Official Notification - Federal Boat Safety Act Sport Jet 90

1993 and 1994 SPORT JET 90

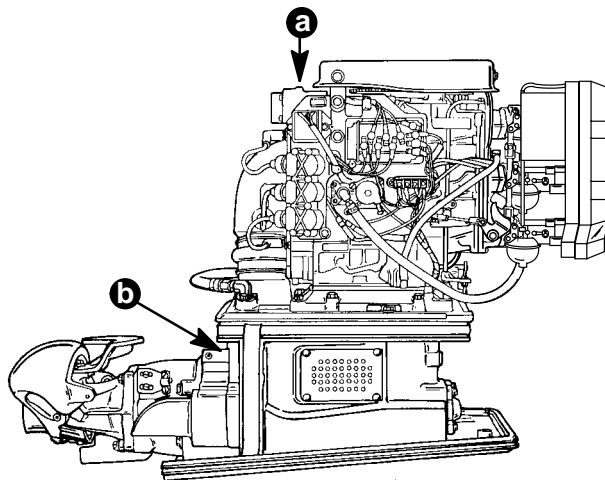
Sport Jet 90 units have two serial numbers. Please note that the serial number at the powerhead (a) is not the same as the pump (b). Sport Jet 90 units may have a field campaign involving both the powerhead and the pump.

a - Power Head Serial Number
b - Jet Pump Serial Number

LOCKING TAB - SHIFT CABLE CLAMP

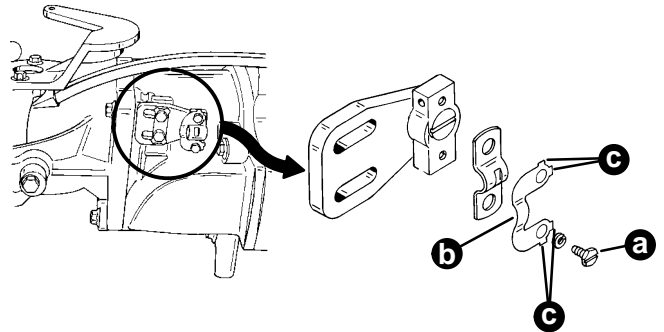
We have some reports of the shift cable clamp screws loosening. This condition can result in loss of shift control.

1. Install a tab lock, p/n 14-820601, as shown in the figure below with radius portion (b) of the tab lock towards the reverse gate.
2. Torque screws (a) to 50 lb. in. (5.65 N·m).
3. Bend tabs (c) over flats of the screw head.

a - Screw (2)
b - Tab Lock- Positioned Toward Reverse Gate
c - Locking Tabs

PIVOT BOLT - REVERSE GATE

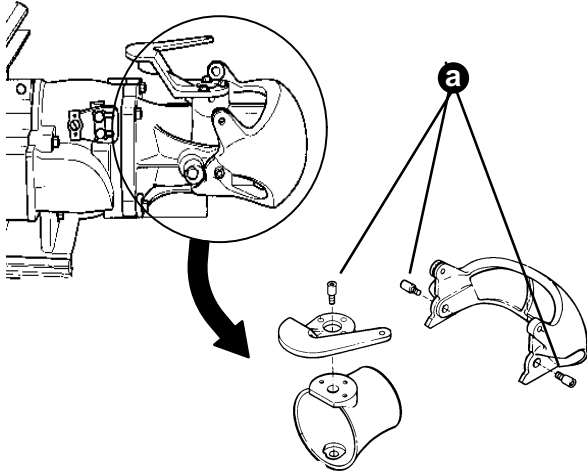
Loose reverse gate pivot bolts have been reported on some pumps. This condition can lead to loss of shift control.

1. Remove three pivot bolts (a) as shown in the figure following.

- Apply Loctite #271 (p/n 92-32609-1) to threads of the pivot bolts.
- Install pivot bolts (a) and torque to 25 lb. ft. (33.89 N·m).

a - Pivot Bolts (3)

**GROUP #3
BOOT - STARTER SOLENOID**

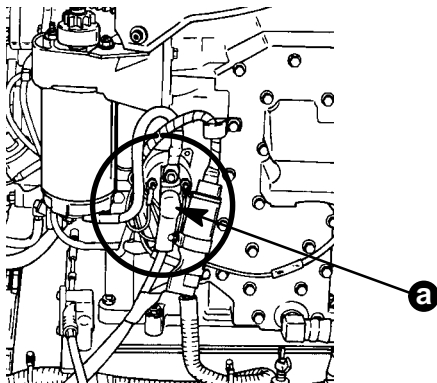
The U.S. Coast Guard recently cited two boat builders who were in violation of regulation #33 CFR 183.445 (b) which requires that the “positive” battery cable connection at the starter solenoid terminal be protected by either a boot (a) or protective shield.

a - Boot, Positive Battery Terminal

For the convenience of all parties (the consumer, dealer and boat builder), inspect the starter solenoid terminal connection with the “positive” battery cable to see if it is protected with a boot. If it is not, order the boot (p/n 85-79695) and install on the terminal connection of the “positive” battery cable and terminal of the starter solenoid.
